Engineering Department Land Use Application Review Comments & Conditions

To: Eric Rutledge, Associate Planner
From: Craig Christensen P.E., Civil Engineer
Project: Cedar Creek Gardens Subdivision (LU 2021-023)
Date: June 13, 2022

**Design Modification Request to Exceed the Maximum Spacing Between Intersections
Along Street “B” Between Street “A” and the East Property Line – Section 210.6.E.**
LU 2021-023 SUB Cedar Creek Garden Completeness Review – January 13th, 2022

Design Modification Request to Reduce the Minimum Length of Road Between Intersections between SW Brookman Road and Street 'B' – Section 210.6.E.
LU 2021-023 SUB Cedar Creek Garden Completeness Review – January 13th, 2022

Exhibit A – Sheet P3.0, Preliminary Plat

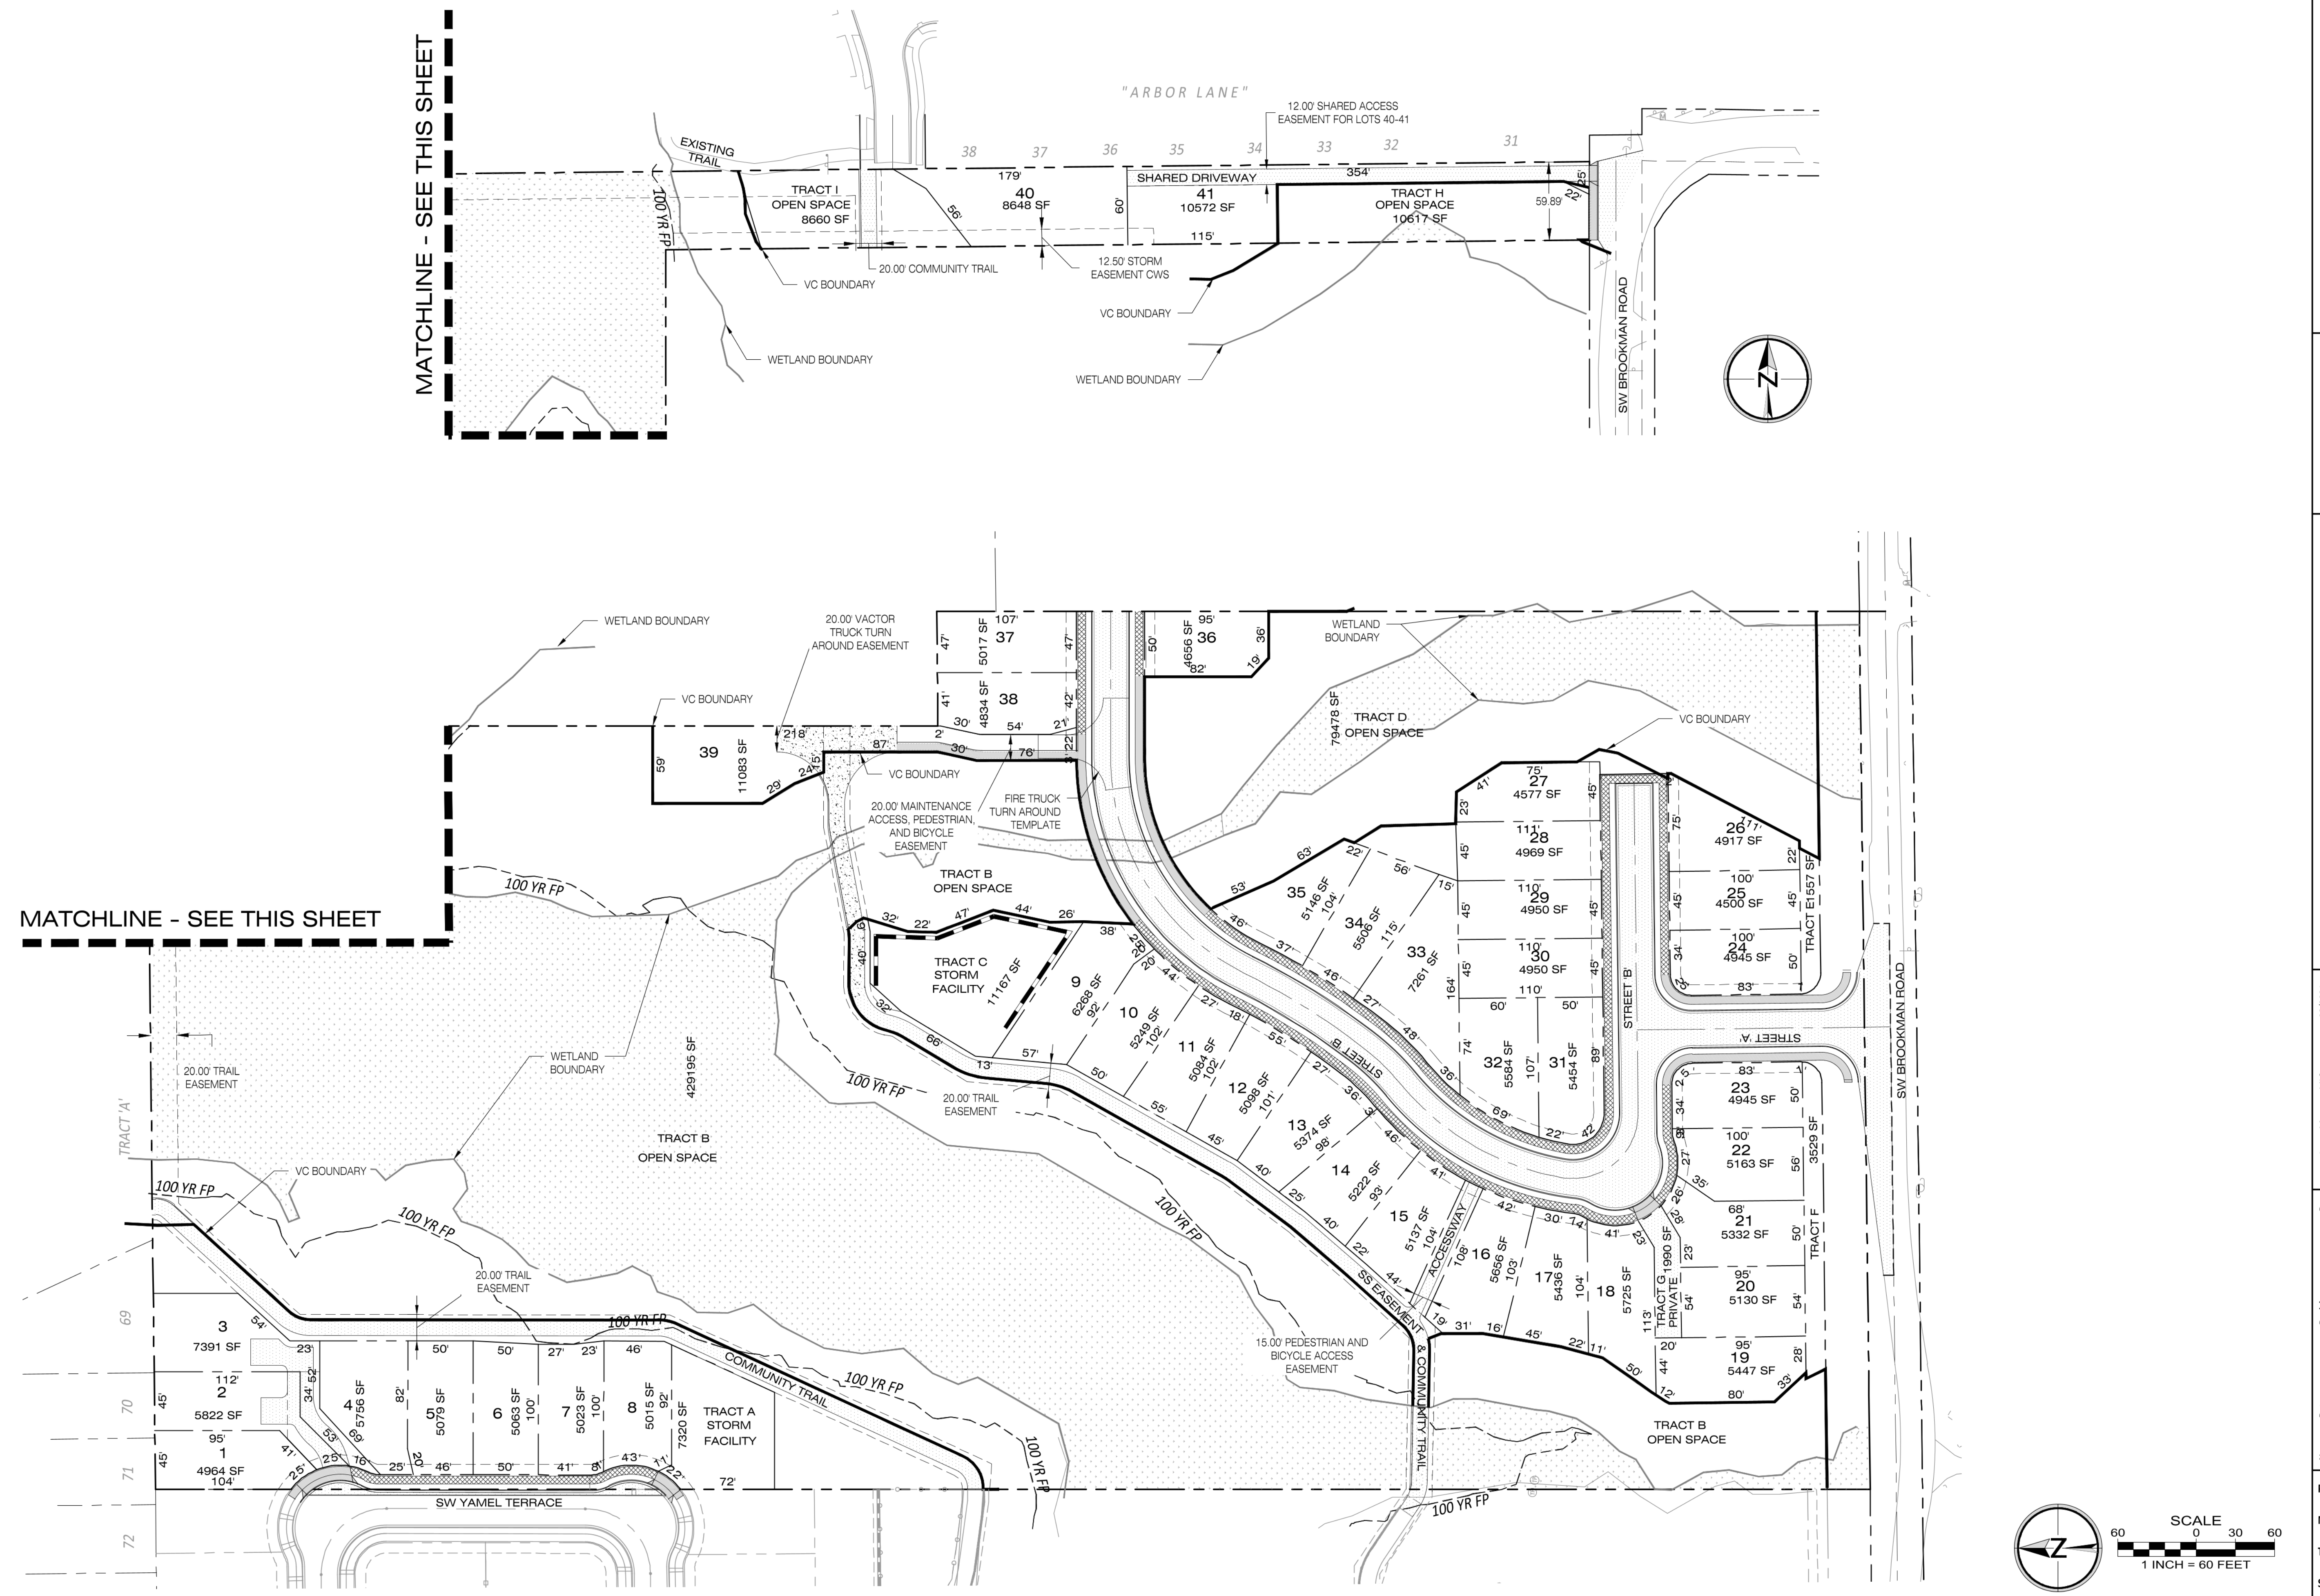
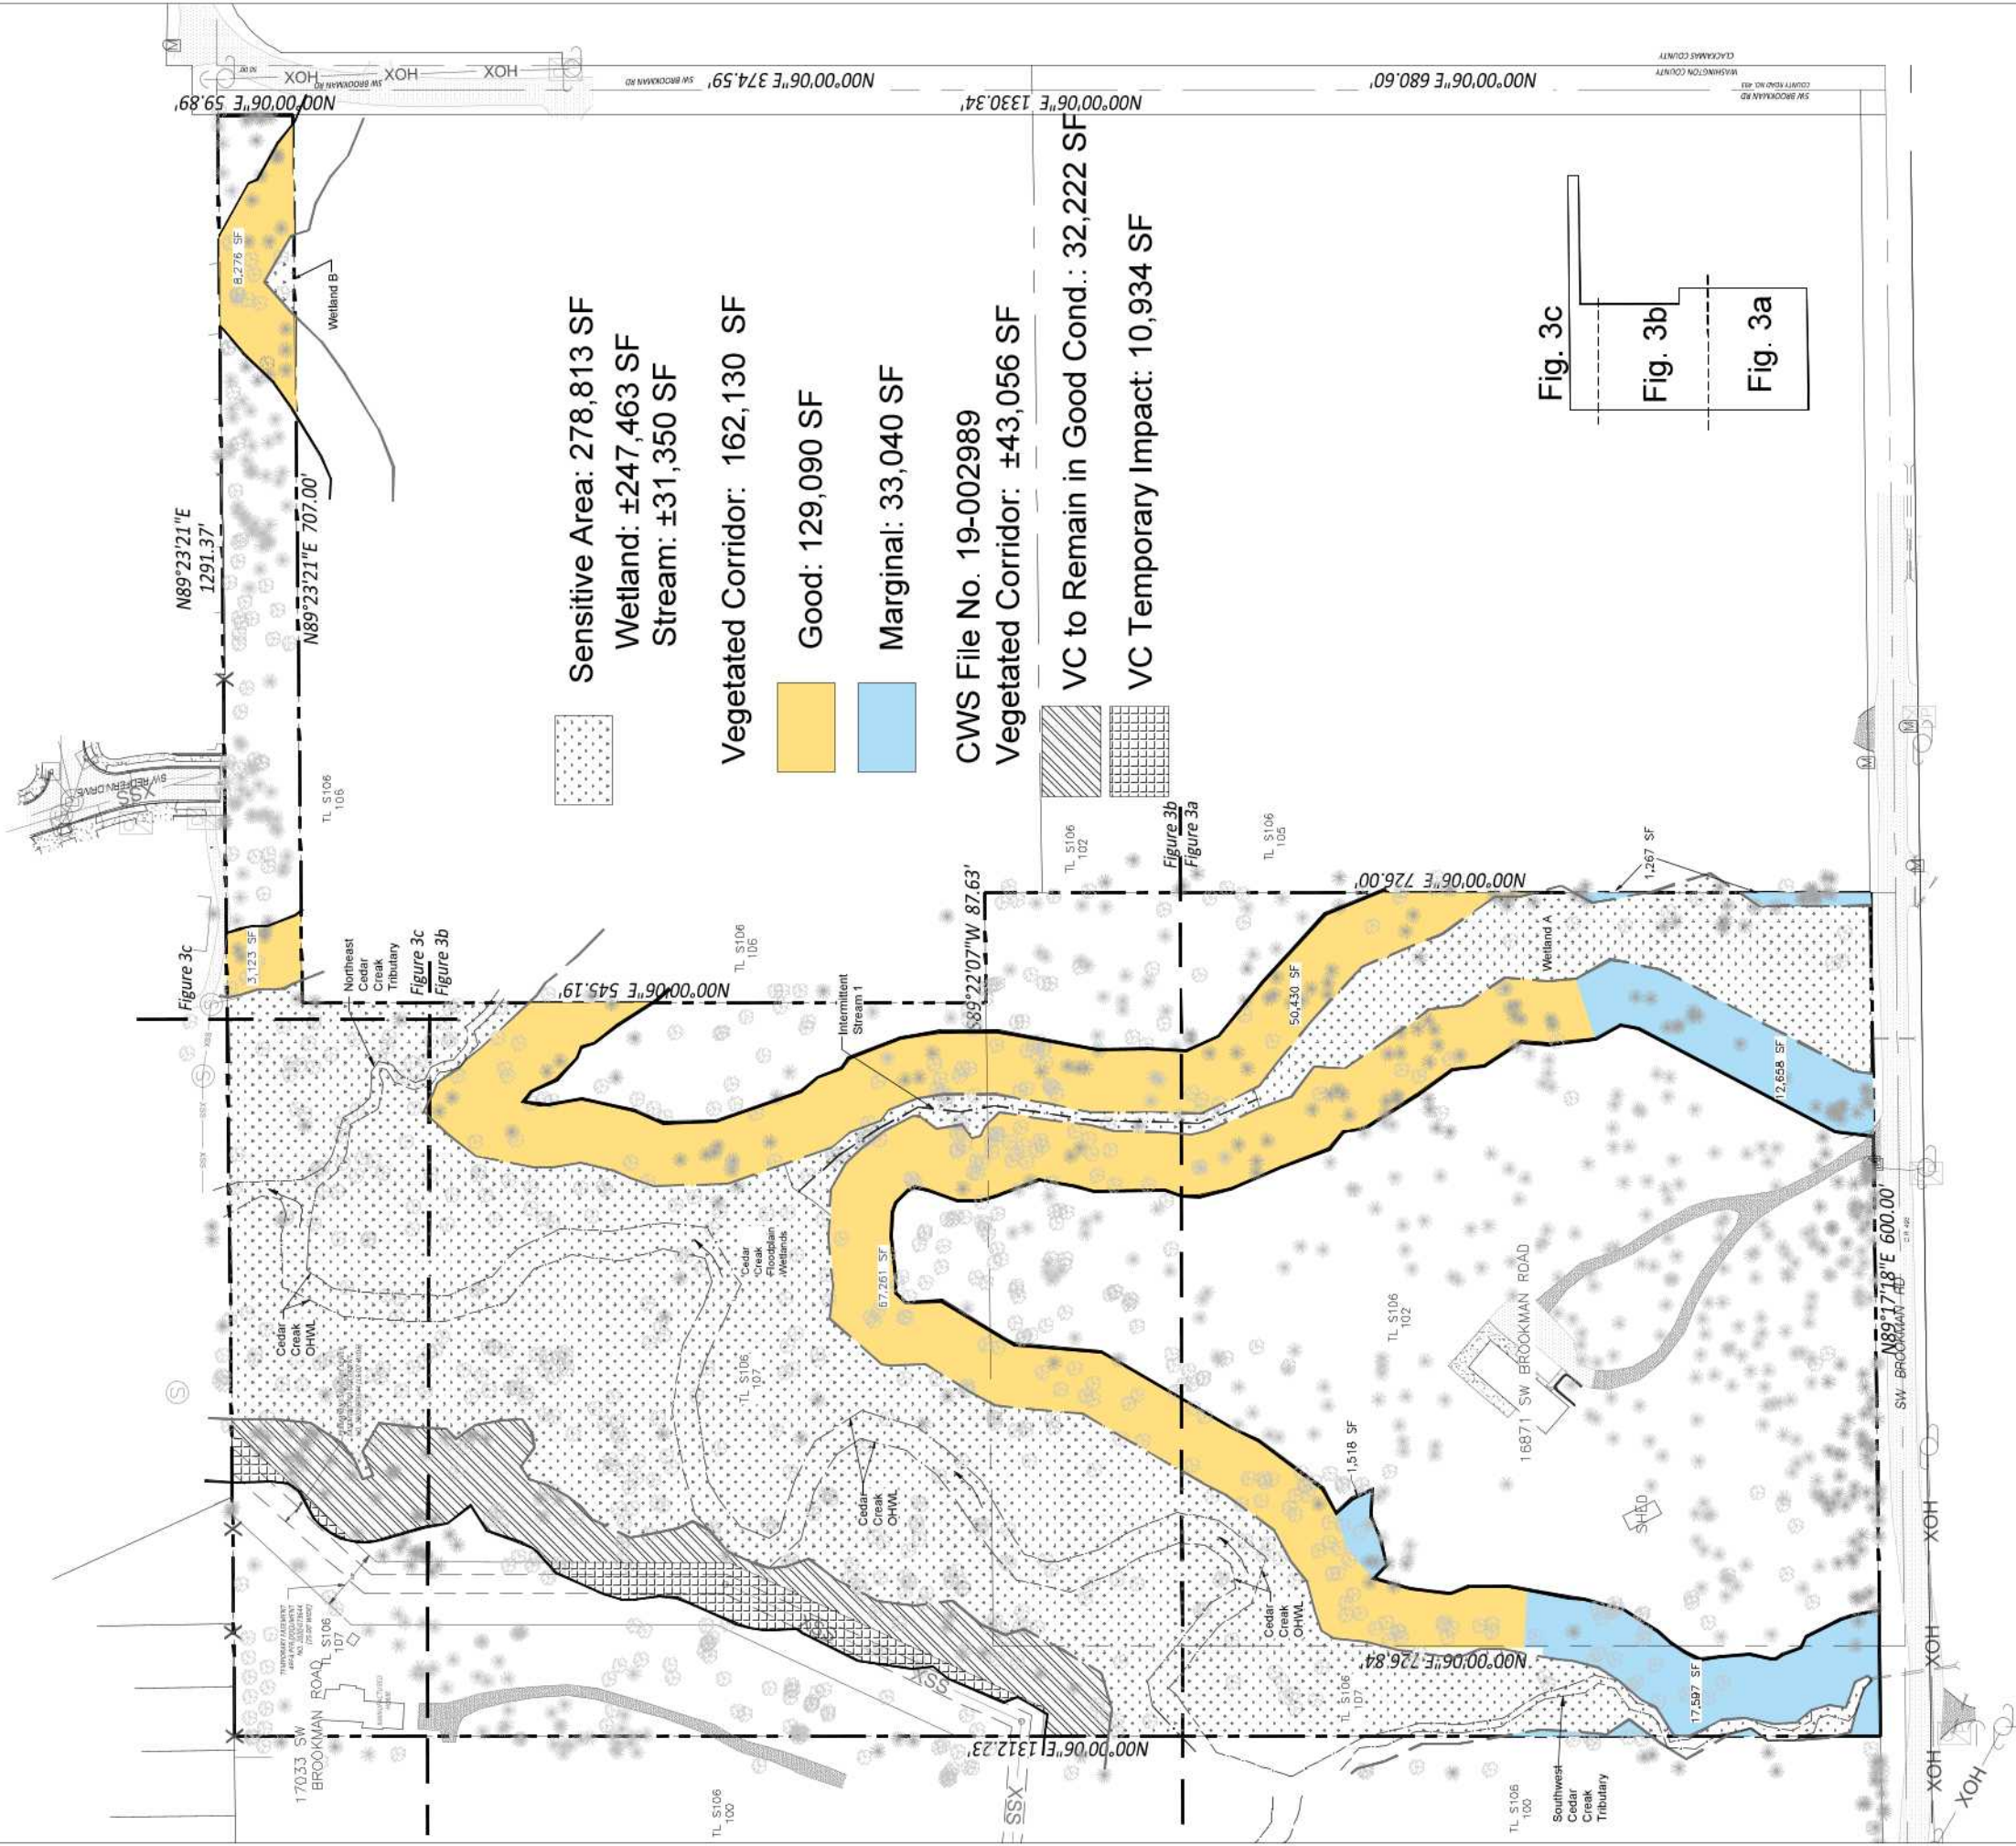
SW Brookman Road, a County arterial street, is located along the southern boundary of the site. Proposed Street “A” provides access to the site from SW Brookman Road, further intersecting with Proposed Street “B”, which in turn serves proposed Lots 9 – 39 before terminating as a street stub at the eastern shared boundary with Tax Lot 105 (Exhibit A – Sheet P.3.0., Preliminary Plat).

- Approved
- Approved with Conditions (conditions below or on attached sheet)
- Denied

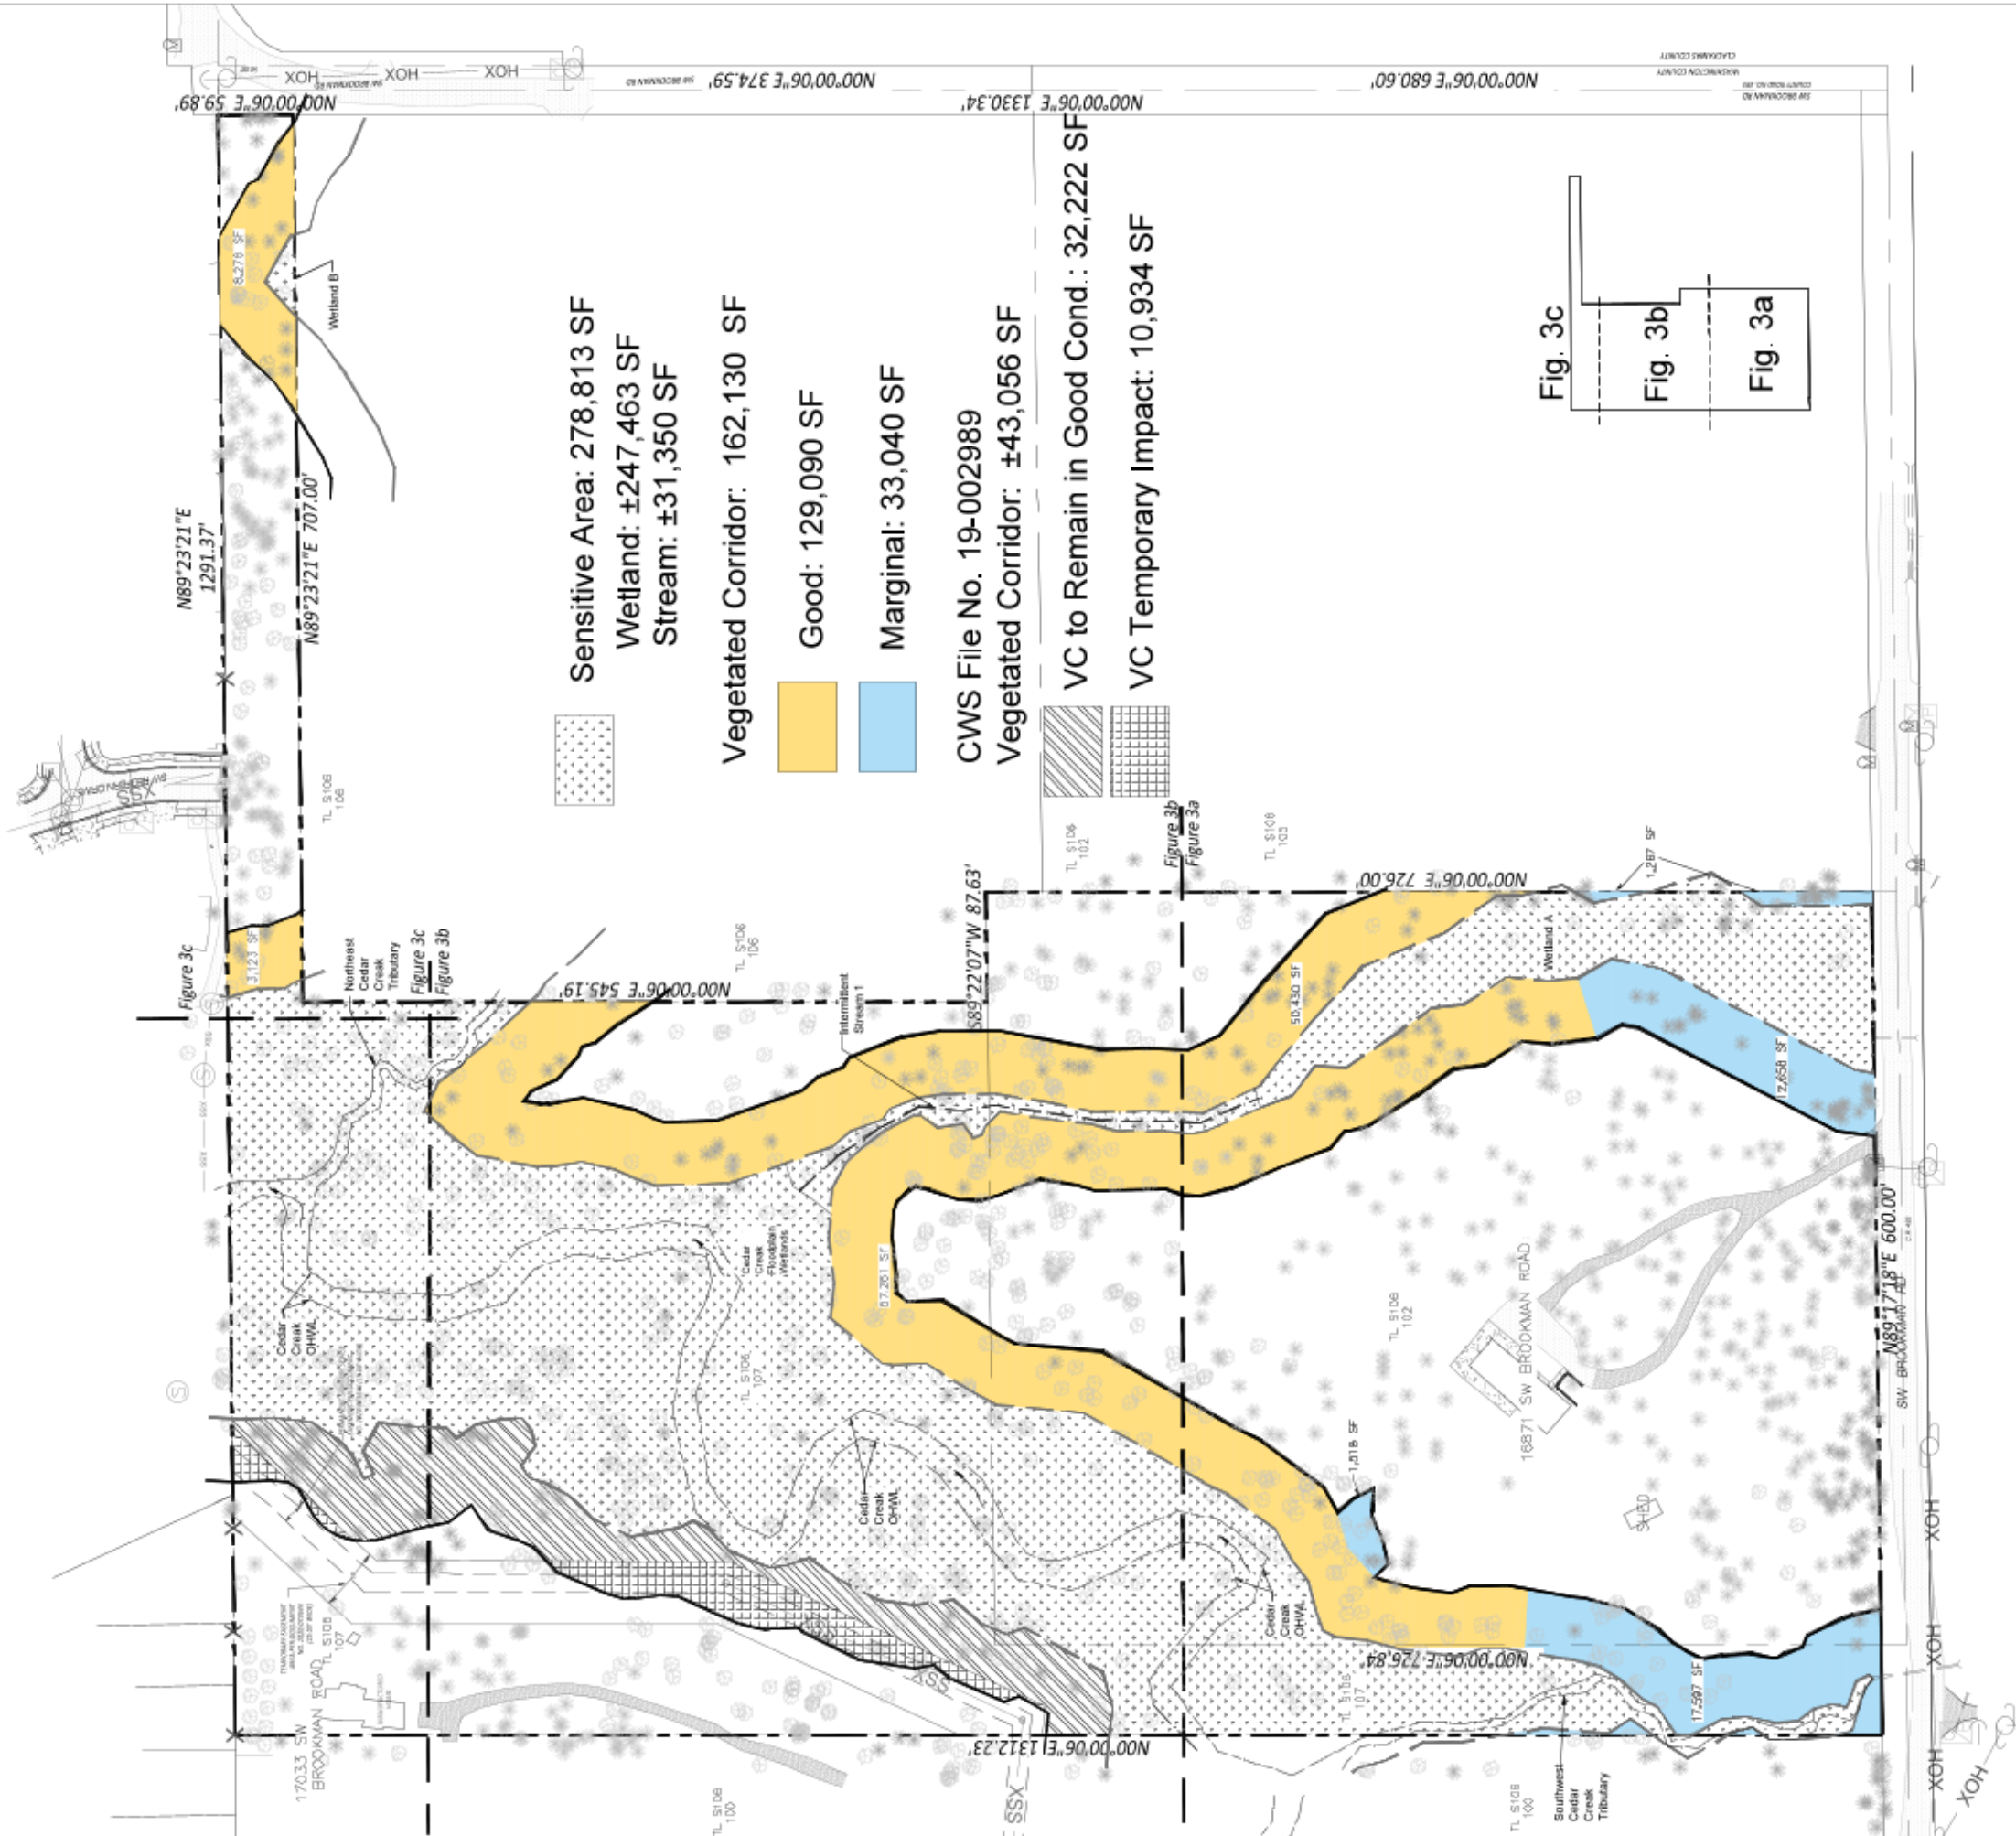
BOB, ALTHOUGH I BELIEVE THAT THIS STANDARD COULD BE MET, IT WOULD LIKELY END UP WITH A SKEWED OR REVERSE CURVED DEAD END WHICH WOULD MAKE FOR ODD LOT LAYOUT. ULTIMATELY THE 6 FEET OF LOSS BETWEEN THE INTERSECTIONS IS NOT SIGNIFICANT AS THERE IS STILL QUEUEING LENGTH FOR 6 VEHICLES IN STREET 'A'.

- Approved
- Approved with Conditions (conditions below or on attached sheet)
- Denied
